SUBJECT: **144 Seekonk Street Traffic Study**

DATE: **February 11, 2020**

This memorandum responds to TEPP's Traffic Peer Review dated January 28, 2020, which evaluated sight lines for the proposed driveway at the 144 Seekonk Street development ("Lakeland Hills") in Norfolk, Massachusetts based on AASHTO guidance for a 40 mph design speed. We note that the 40 mph design speed was based on speed data collected in December of 2016. Sometime in 2018 an "Intersection Ahead Sign" and 25 mph advisory plaque were installed on Seekonk Street. Speed data collected in November of 2019, after the installation of these speed calming measures, revealed an 85th percentile northbound speed of 38.5 mph, which WSP concludes is an appropriate design speed for sight distances at the proposed driveway. (Southbound sight distance were measured at approximately 36 mph). However, we have evaluated the entrance sight lines based on a 40 mph design speed at TEPP's urging in order to identify any potential sight line encroachments on adjacent properties at this higher speed so as to complete our evaluation using a conservative speed variable.

144 SEEKONK STREET STOPPING SIGHT DISTANCE REQUIRED

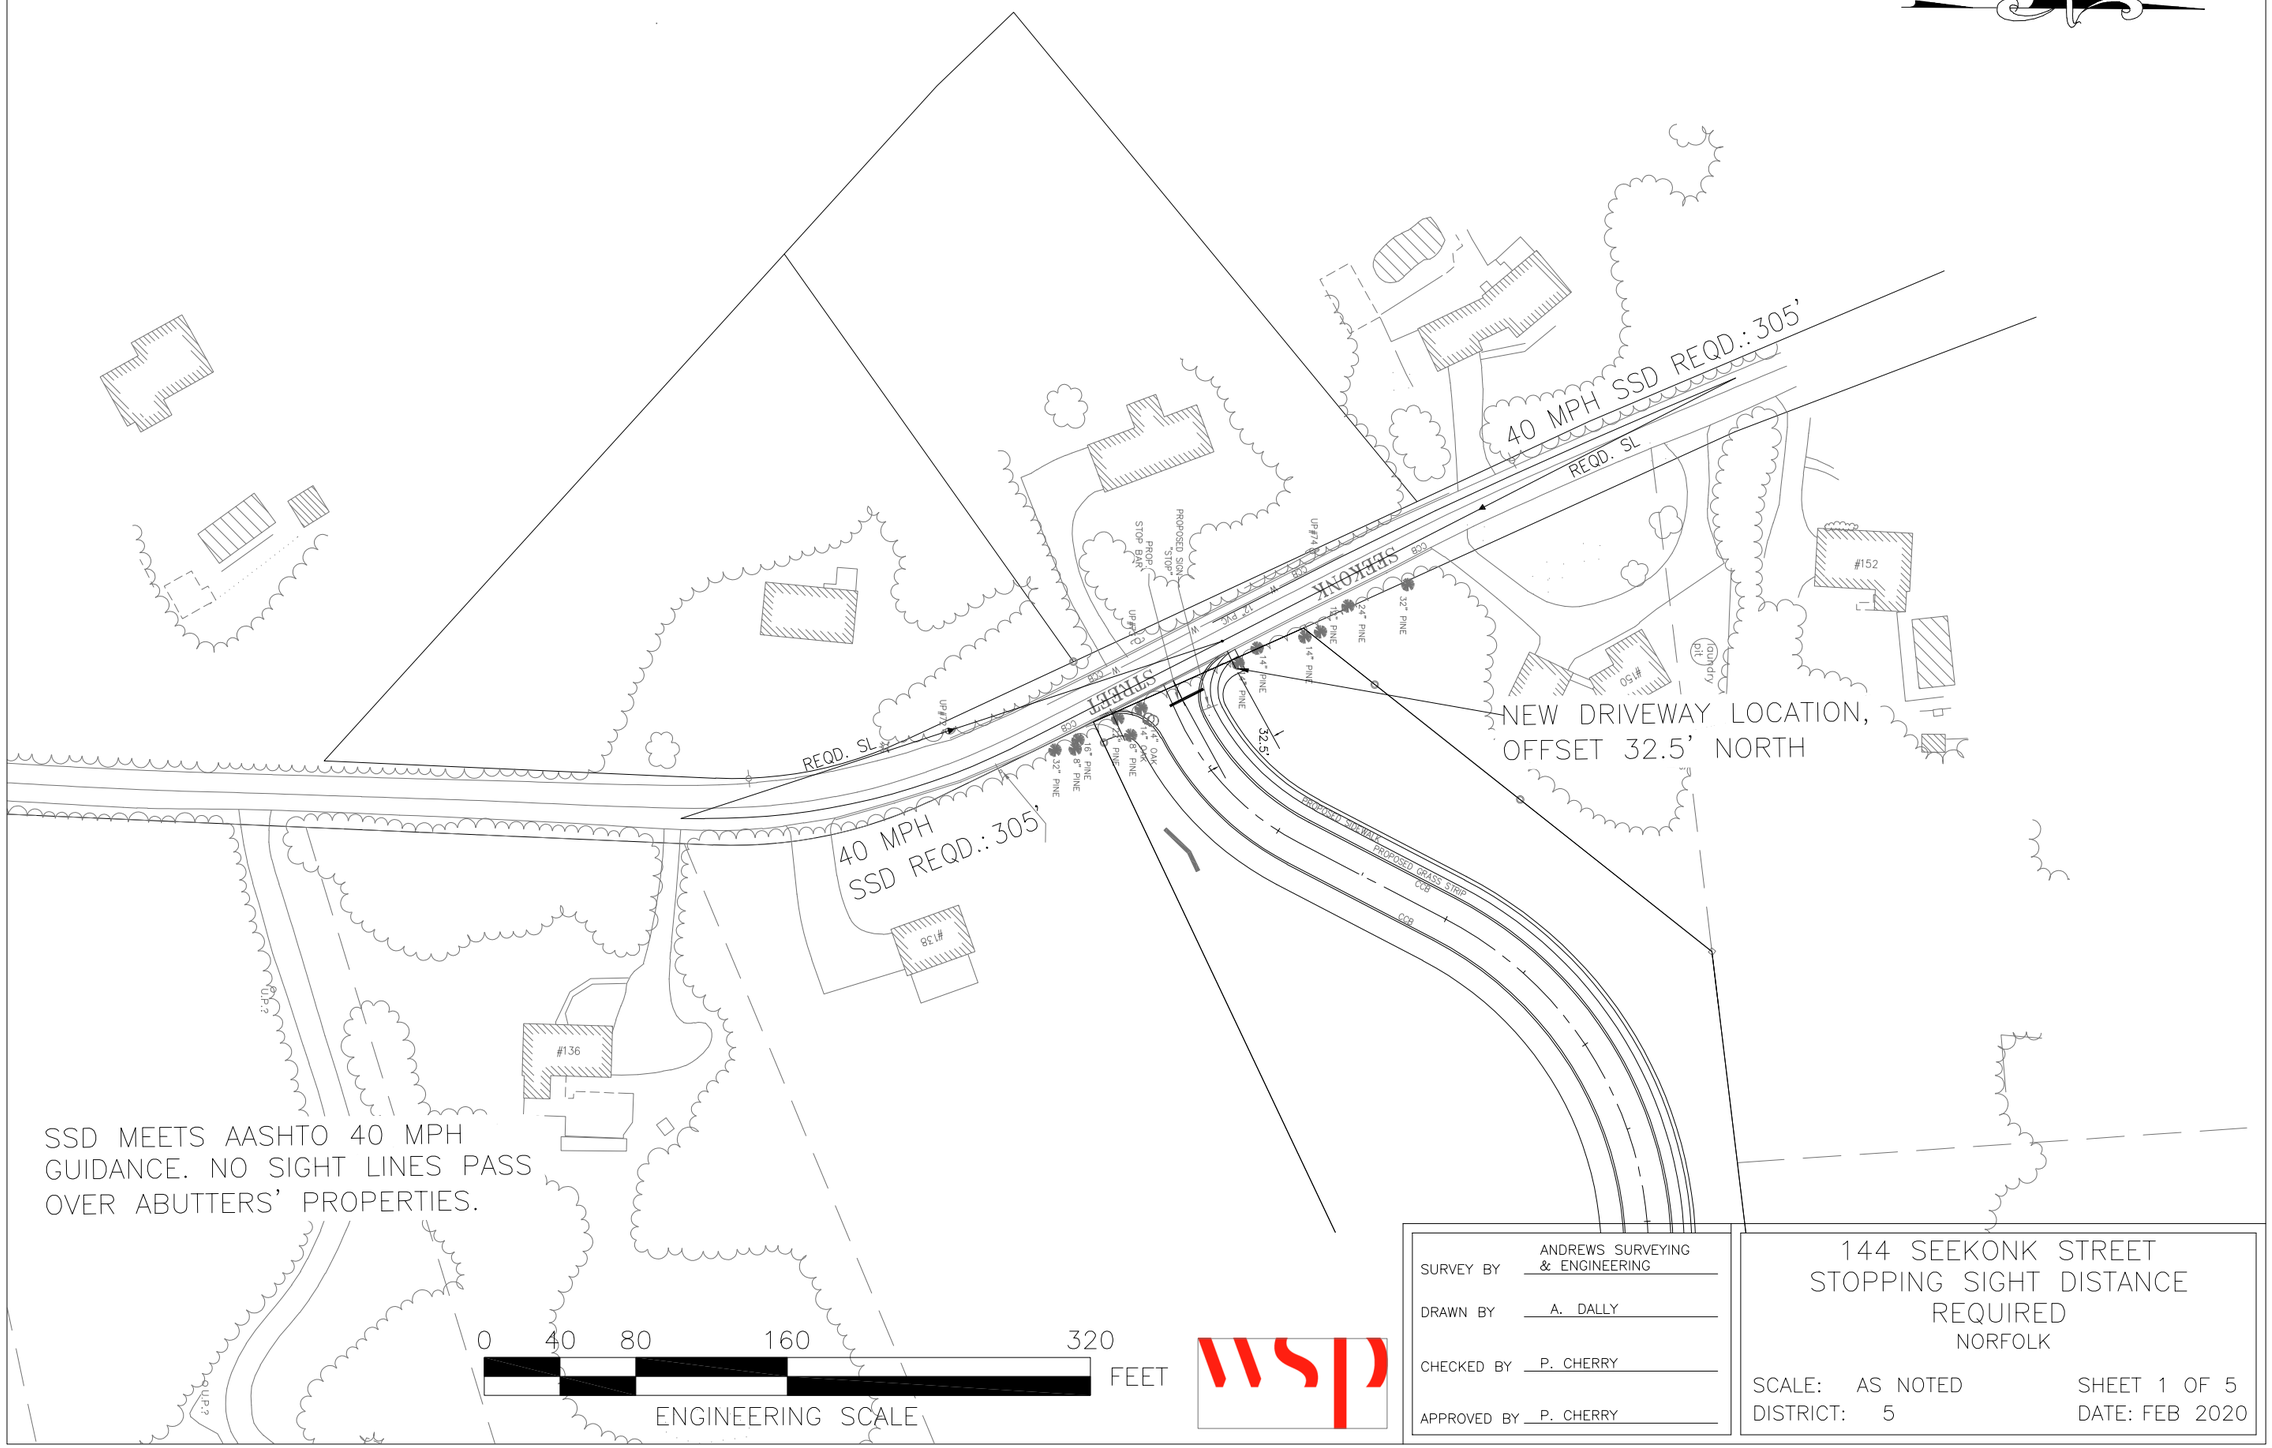
The AASHTO 40 mph SSD guidance is 305 feet. Figure 1 shows that 305 ft sight lines are available in both directions and do not encroach into private ROW at the proposed driveway relocation. Thus, at the proposed relocated driveway, SSD is met.

144 SEEKONK STREET
INTERSECTION SIGHT DISTANCE
REQUIRED AT 10' SETBACK FROM EDGE OF PAVEMENT
NORFOLK

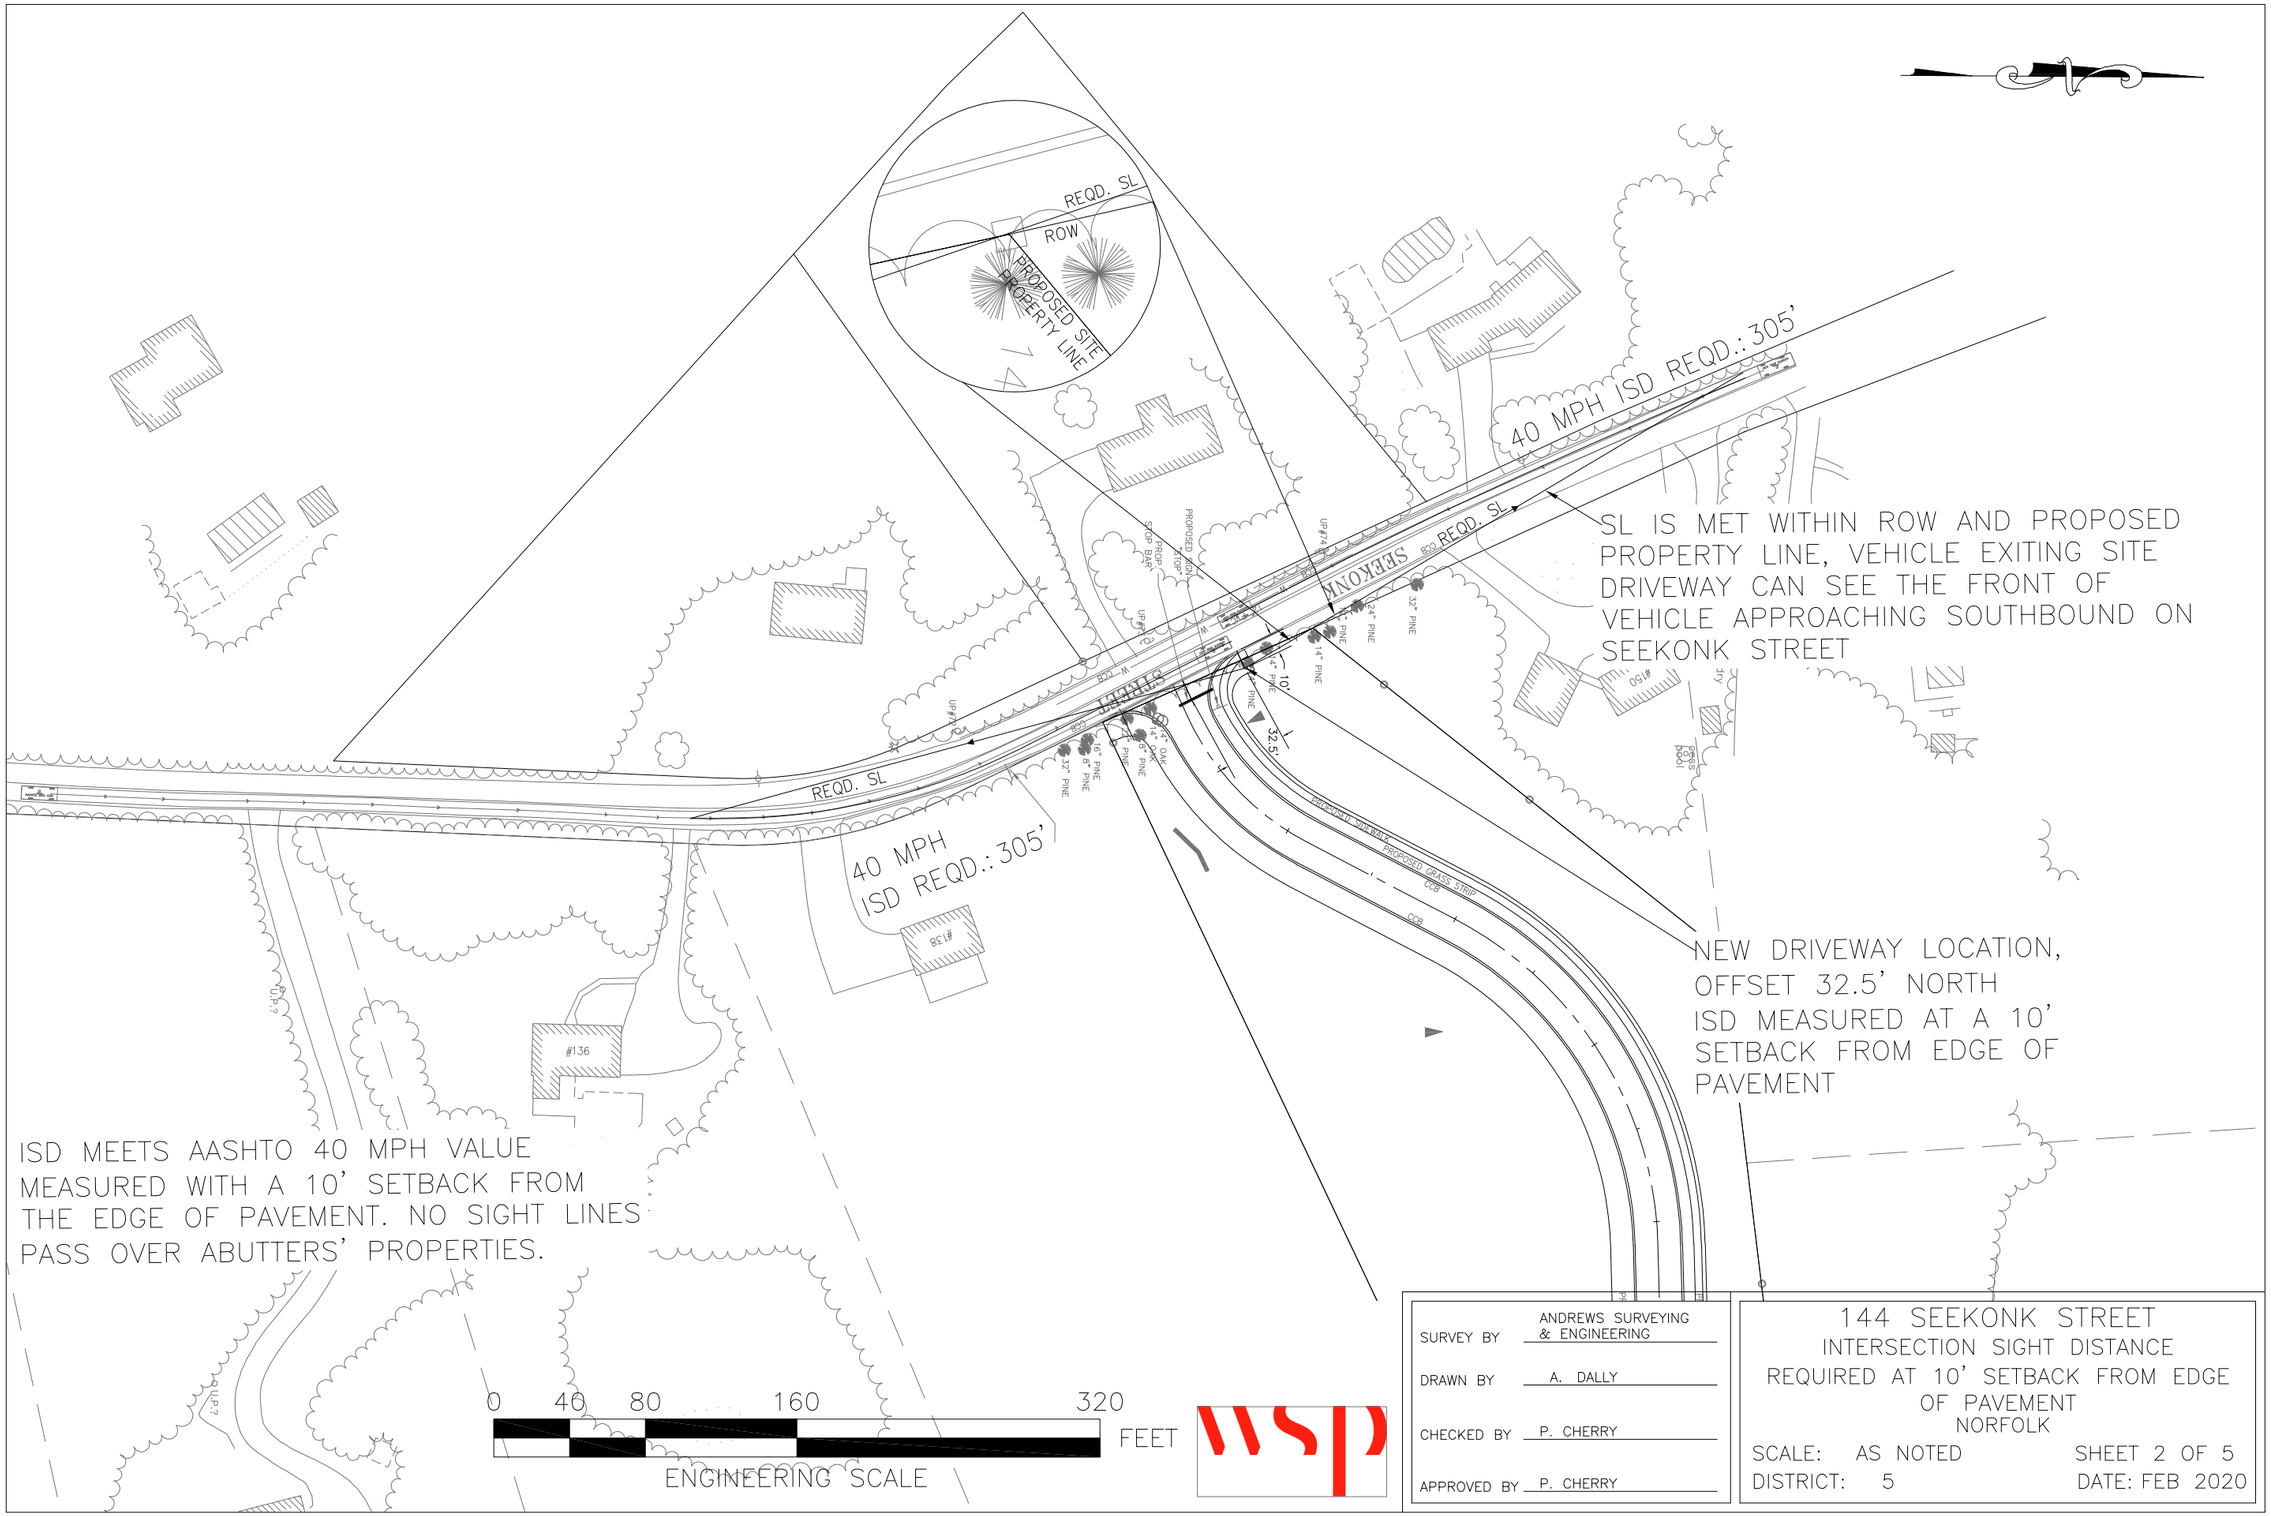
Figure 2 shows that 305 foot sight lines are available to the north and south at a 10 foot setback from the proposed relocated driveway and do not encroach into private ROW.

144 SEEKONK STREET
SUPPLEMENTAL INTERSECTION SIGHT DISTANCE CHECK, MEASURED AT 10' SETBACK FROM EDGE OF PAVEMENT
NORFOLK

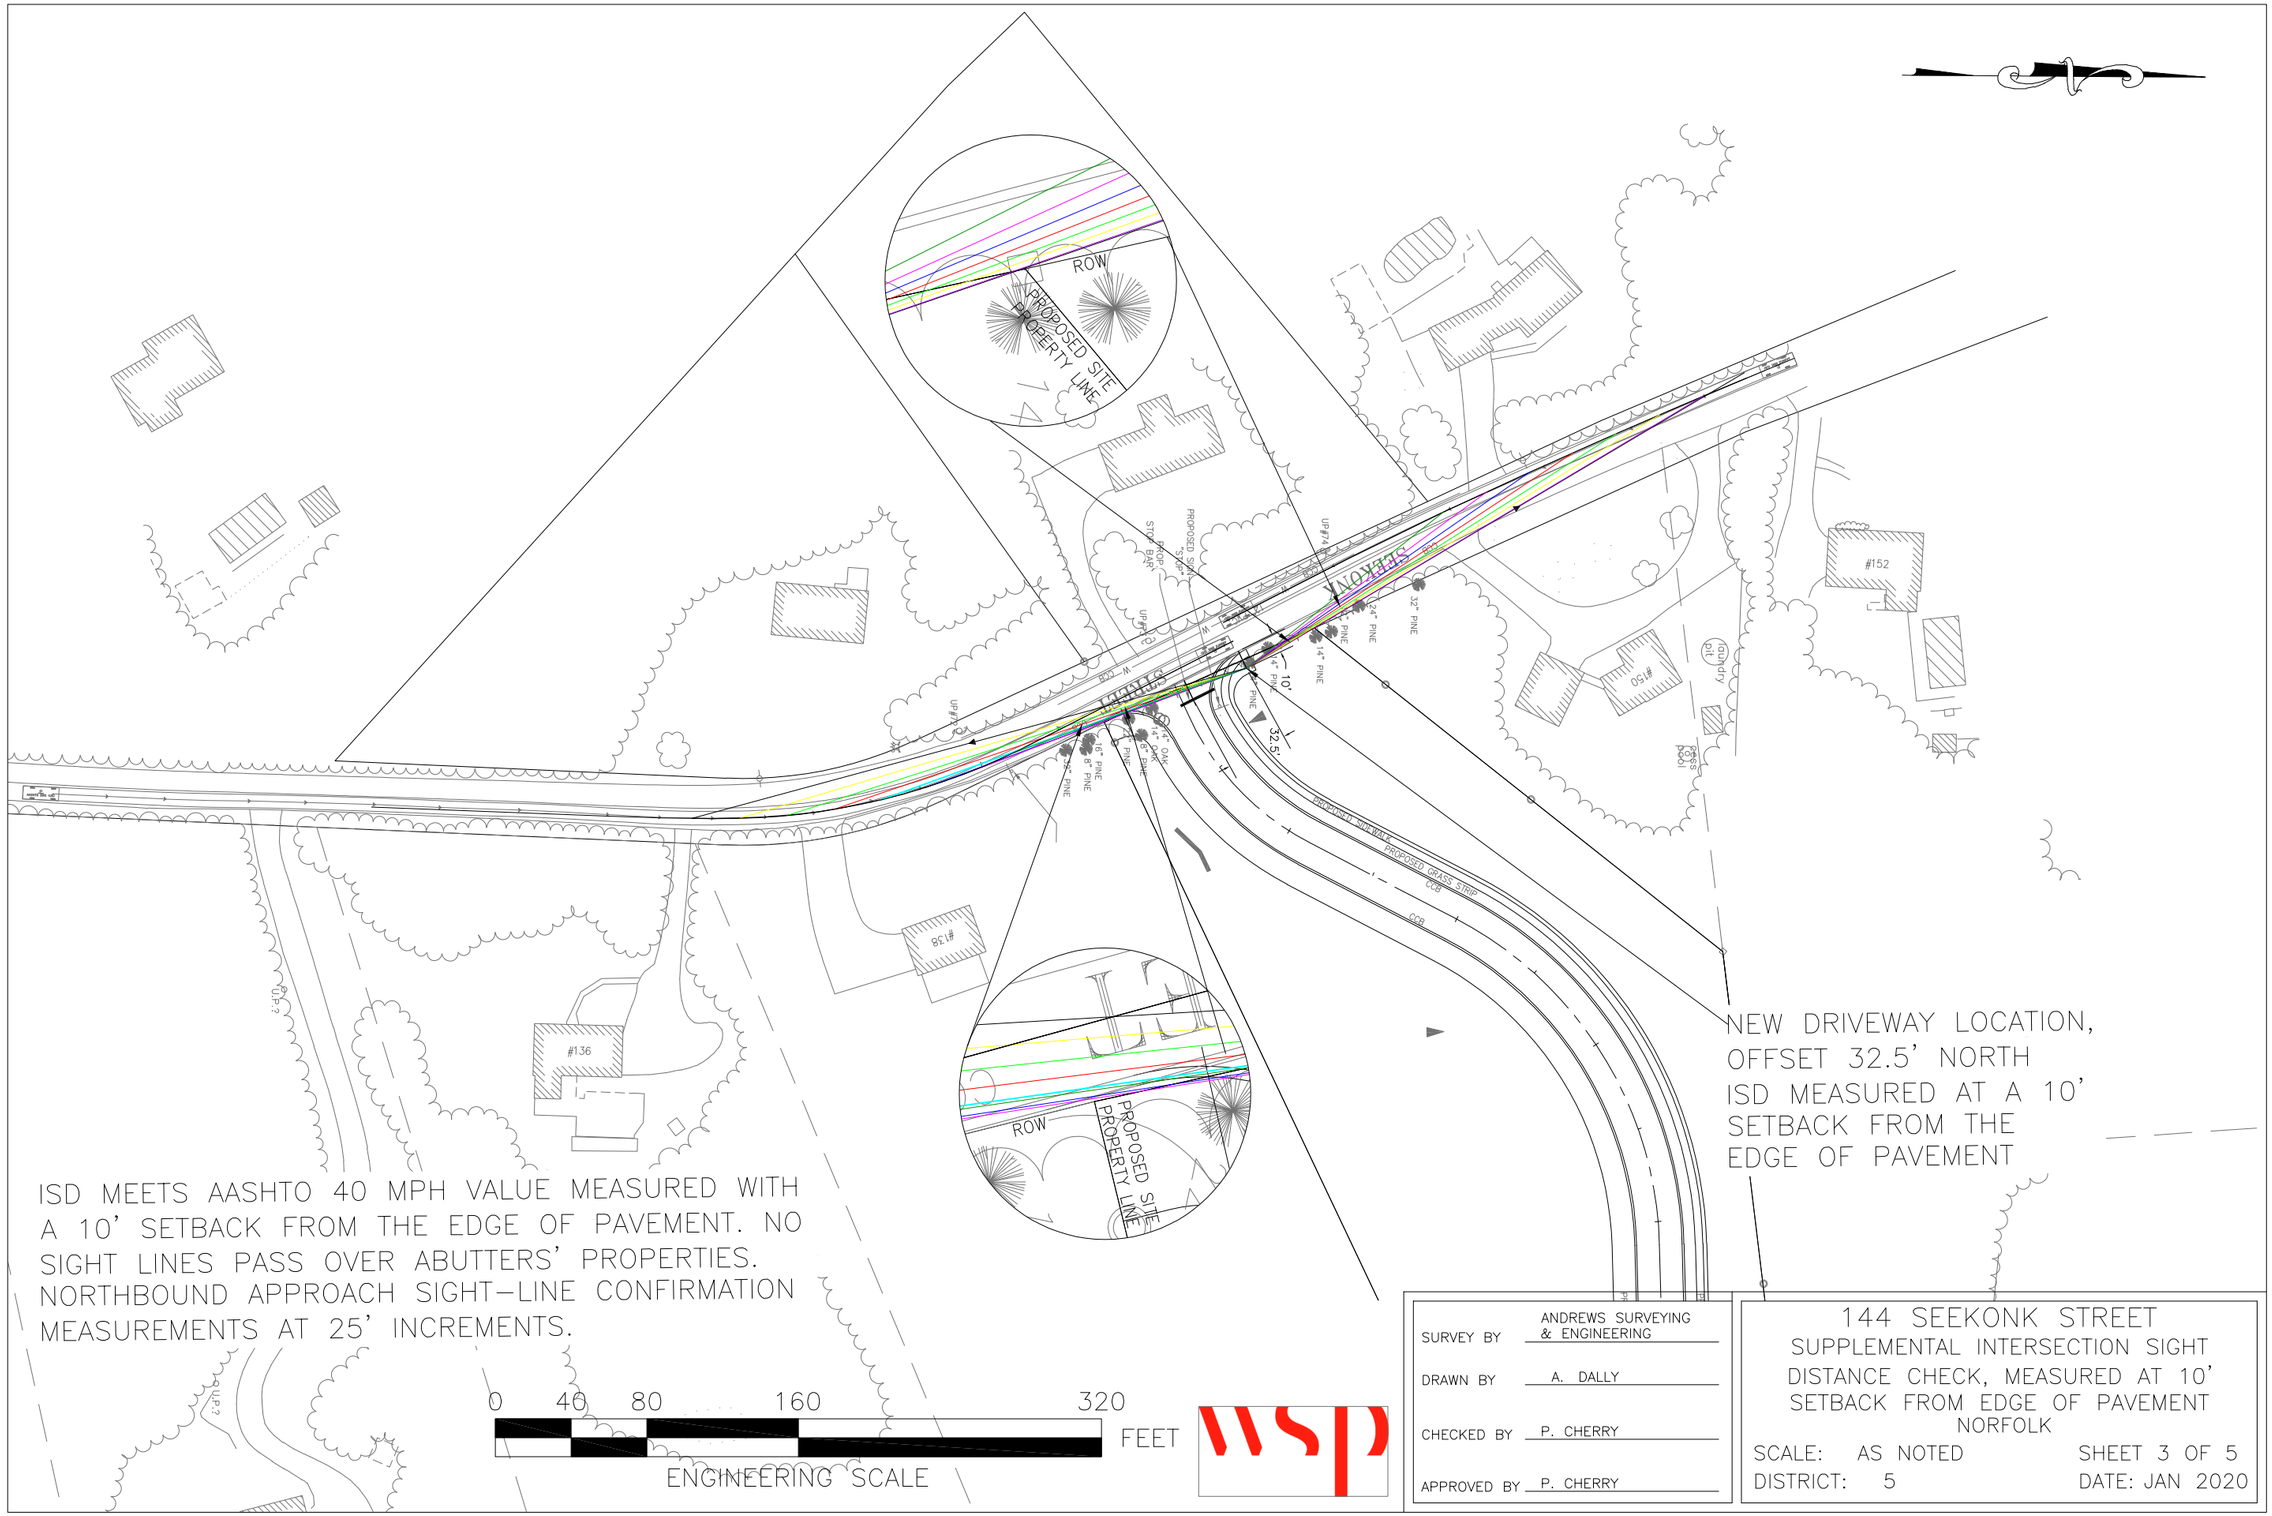
In addition, WSP evaluated sight lines at 25 foot increments along a northbound vehicle path to the south of the proposed relocated driveway to show that the proposed relocated driveway location provides sight lines within public ROW along the horizontal curve in Seekonk Street at a 10 foot setback from the edge of pavement. These sight lines are illustrated in Figure 3. WSP has previously noted that a 10 foot setback from the edge of pavement would allow drivers to stop and then slowly move forward, as is typically driver behavior at driveways.
